MONTGOMERY COUNTY HISTORIC PRESERVATION COMMISSION
STAFF REPORT

Address:	7205 Spruce Ave., Takoma Park	Meeting Date:	1/23/2019
Resource:	Contributing Resource Takoma Park Historic District	Report Date:	1/16/2019
Applicant:	Robert Jones & Jodi Kanter Rick Vitullo, Architect	Public Notice:	1/9/2019
Review:	HAWP	Tax Credit:	n/a
Case Number:	37/03-19C	Staff:	Dan Bruechert
Proposal:	Rear Porch Enclosure

The applicant proposes to enclose the first floor of the rear porch.

PROPOSED SIDE ELEVATION

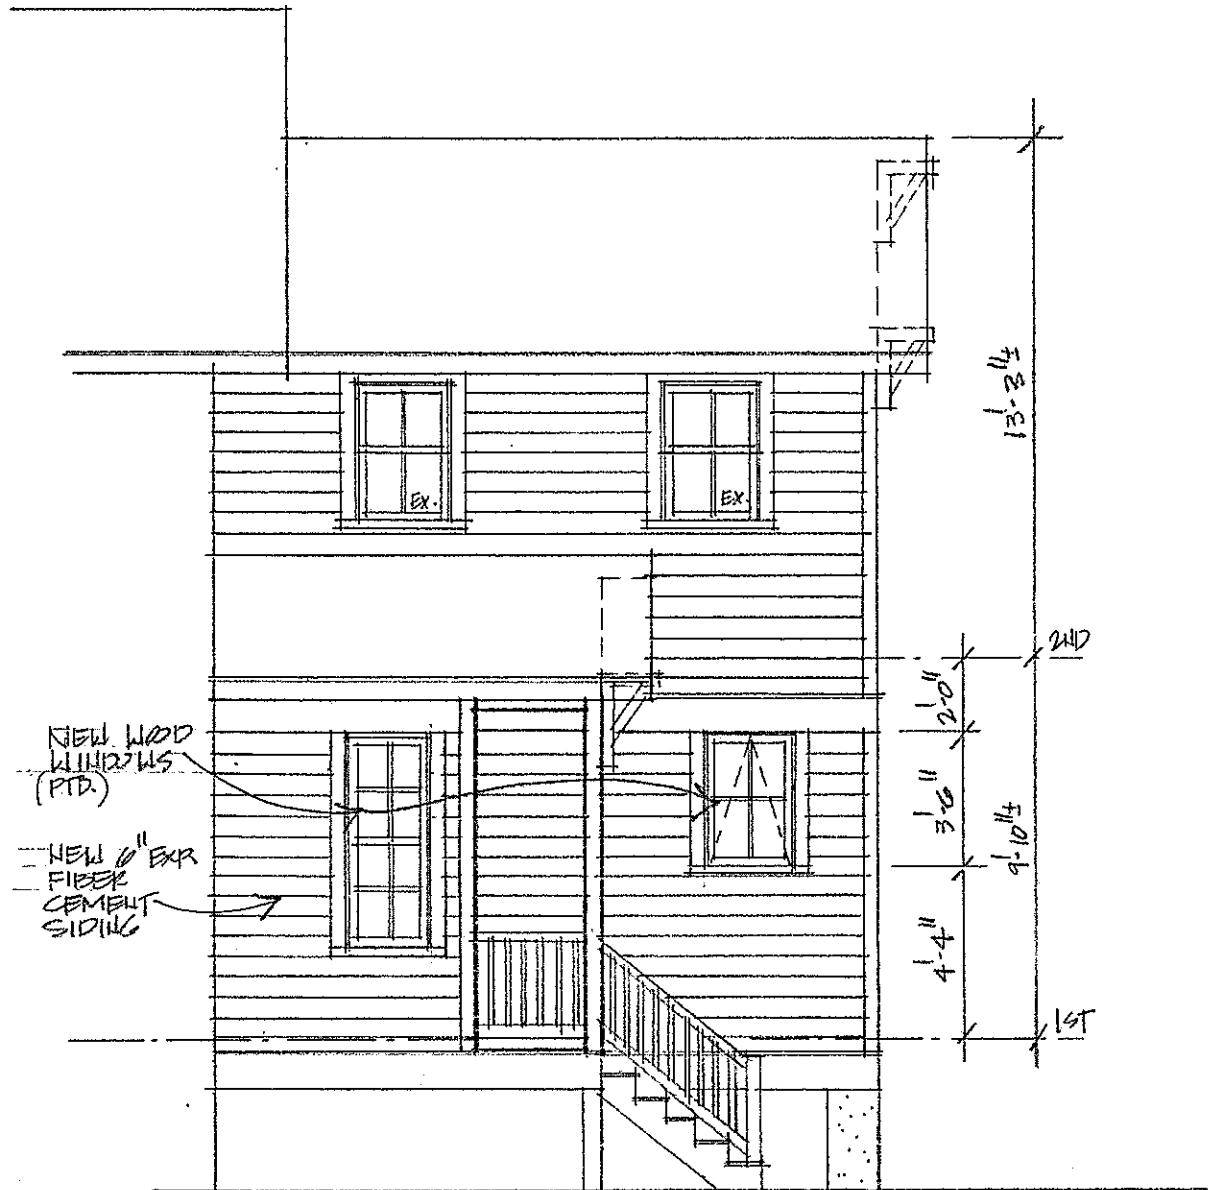
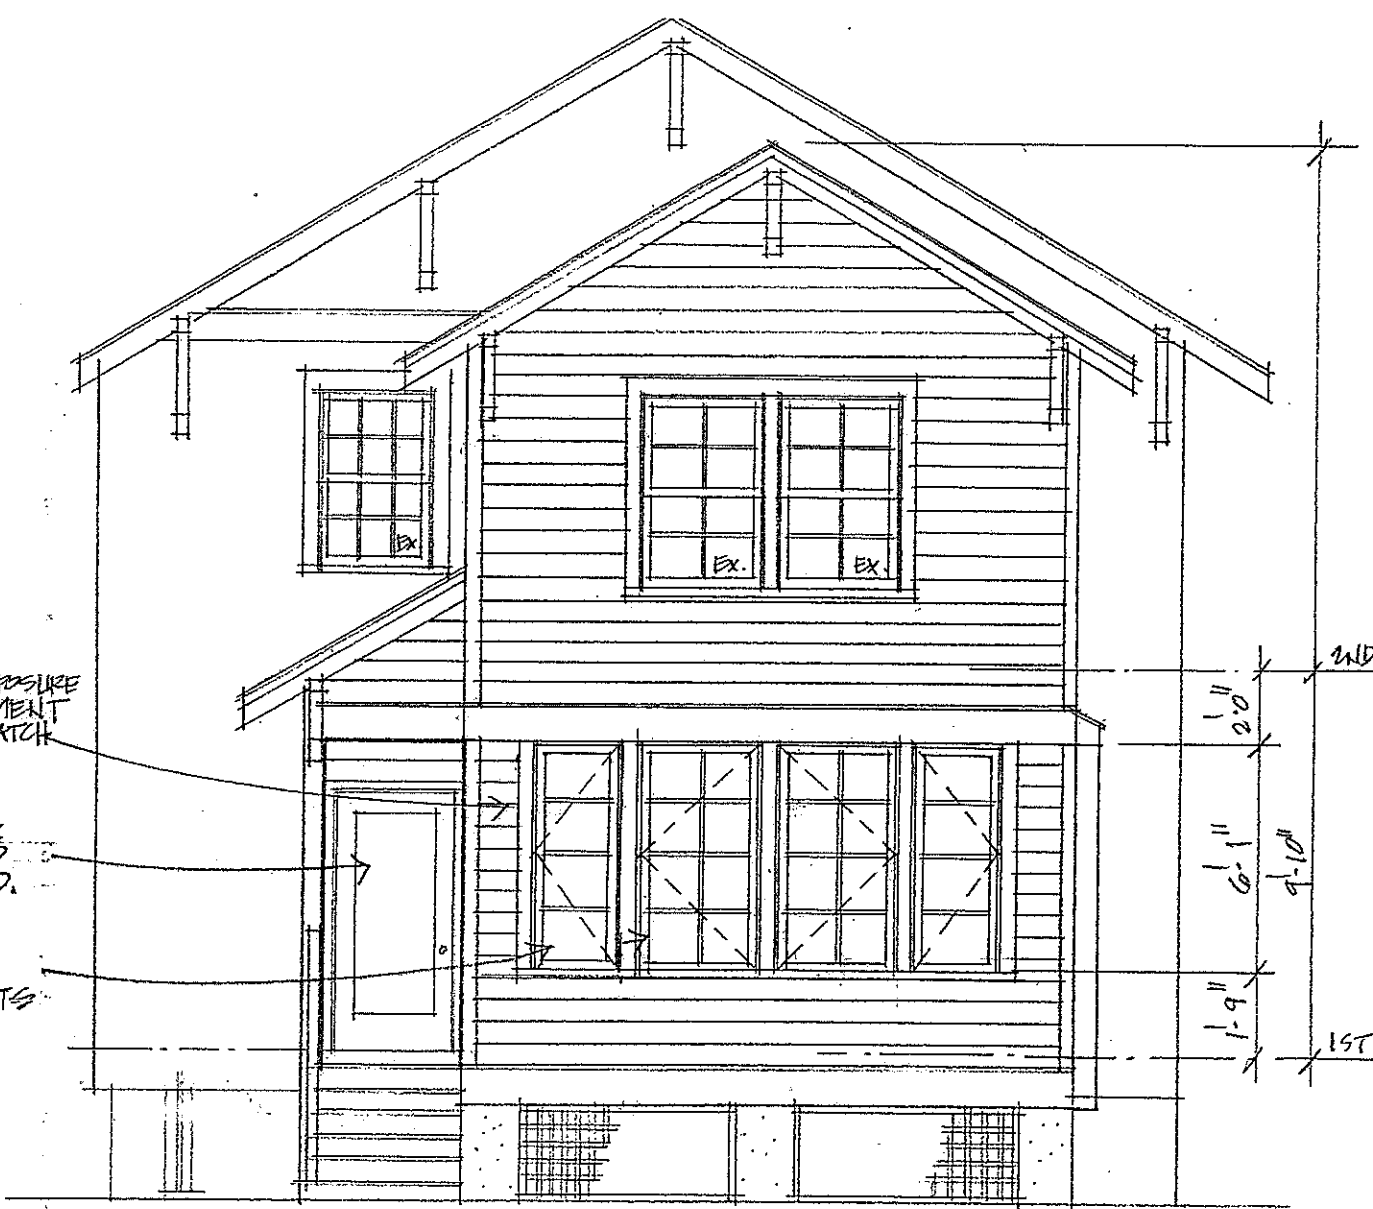
Staff finds that the majority of this work will not be visible from the public right-of-way and should be allowed as a matter of course, per the *Design Guidelines*. Portions of the south elevation (right side) will be visible from an oblique angle. Staff finds that fiber cement siding, such as Hardi, has been determined to be an appropriate material in most instances for new construction and additions to 'Contributing' resources in the Takoma Park Historic District. Staff finds that to be the case here and that the alteration will not impact the historic character of the historic house or the surrounding district. Additionally, the wood casement, awning, and sash windows as well as the new wood door are all consistent materials and configurations with the historic and Staff finds that these are compatible with the character of the house per the *Design Guidelines* and Chapter 24A-8(b)(2).

PROPOSED REAR ELEVATION

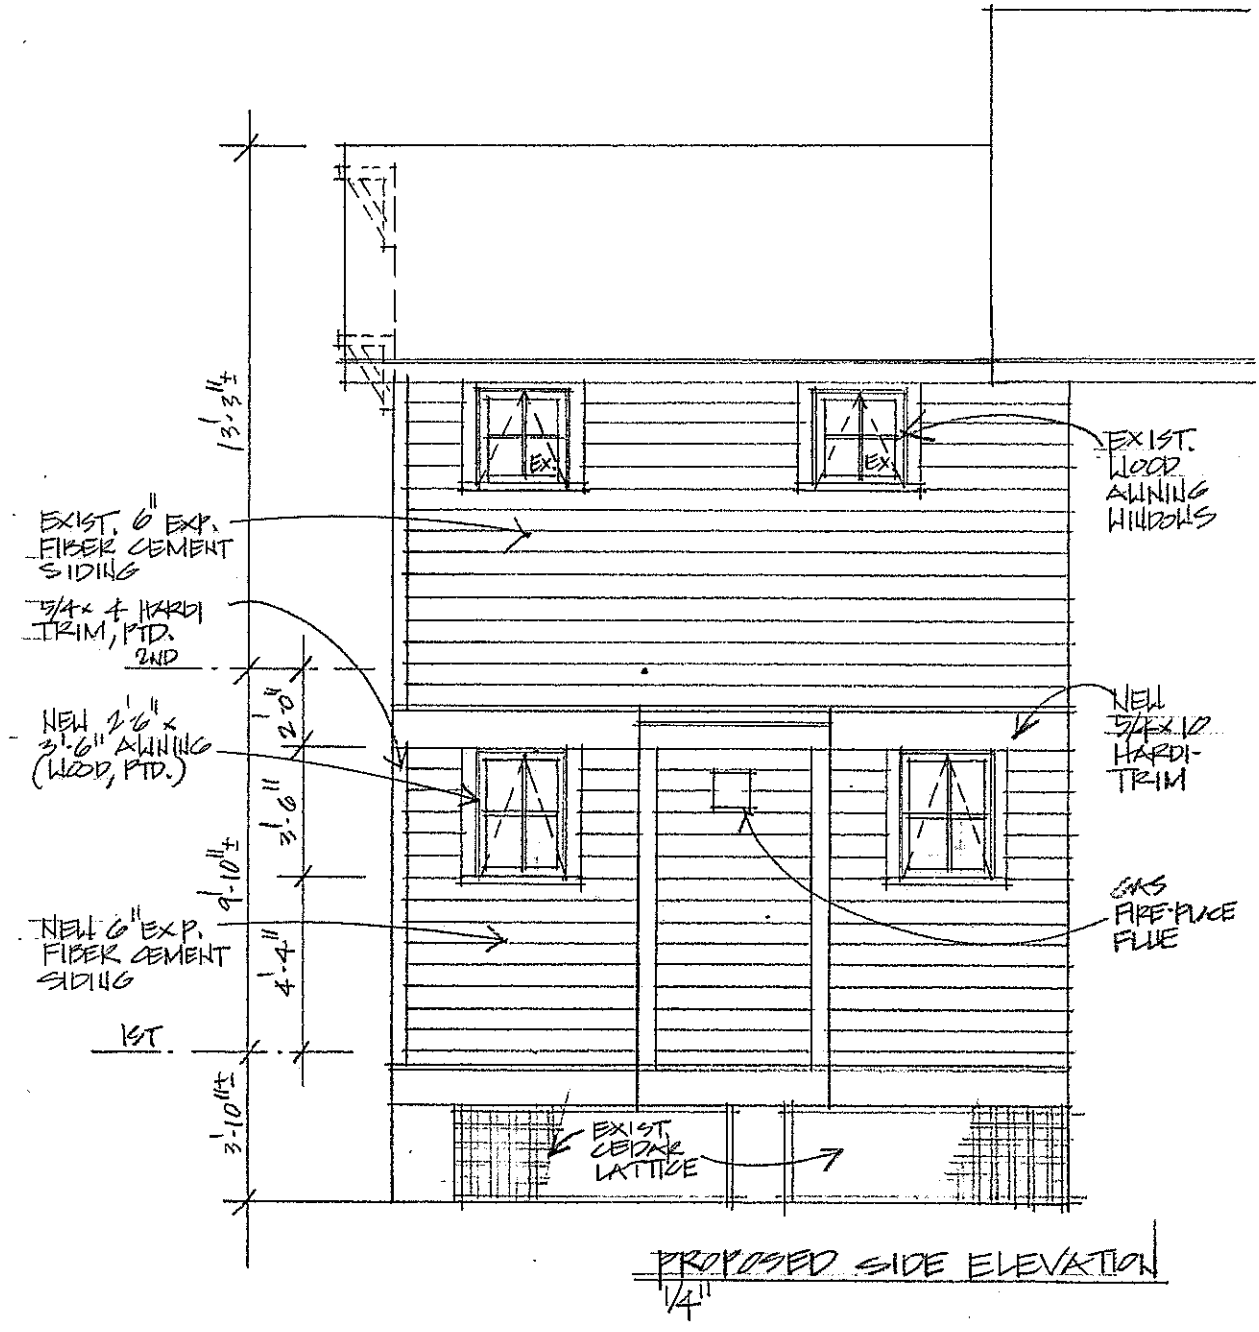
The applicant proposes to enclose the first floor of the rear porch. The siding will be Hardi in a 6" (six inch) reveal to match the material used in the second floor with 4" (four inch) Hardi trim used throughout. The proposed windows will be Marvin wood, simulated divided lite, awning and casement windows. The applicant proposes two awning windows on the left elevation, with a gas fireplace vent in the middle of the wall. At the rear, the applicant proposes to install a pair of eight-lite casement windows flanked by four-lite casement windows. On the right elevation, the applicant proposes one four-lite awning window and one four-over-four sash window adjacent to the rear porch. The applicant is also proposing to install a new wood door at the rear elevation at the top of the stairs to access the newly enclosed porch.
